UNITED STATES PATENT AND TRADEMARK OFFICE

10/828,843

Office Action Summary

DETAILED ACTION

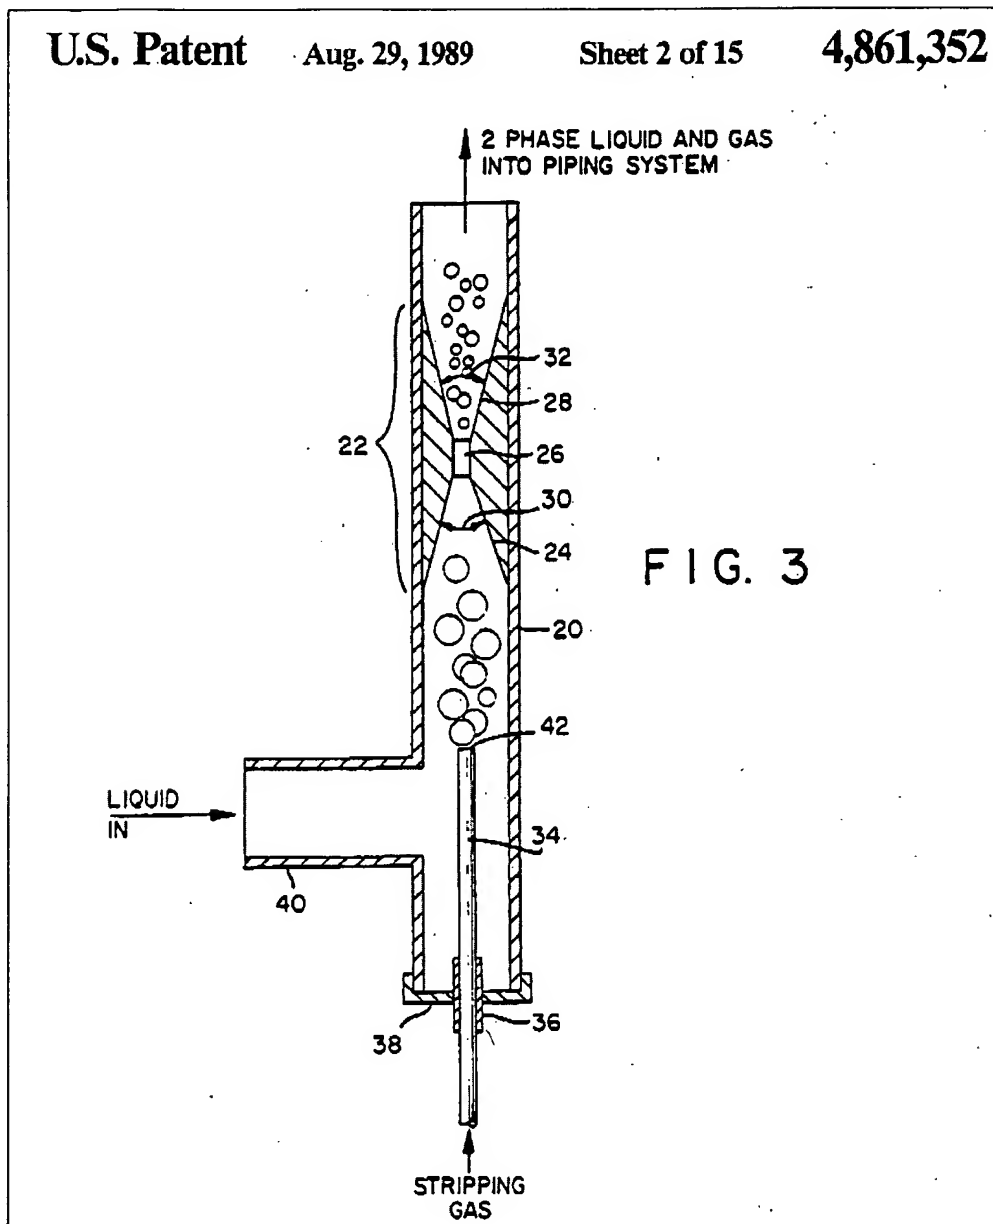
As shown in Fig. 1, Rentschler discloses a water remediation system.

The stripper of Rentschler is in the process flowline, and hence, "*inline.*"
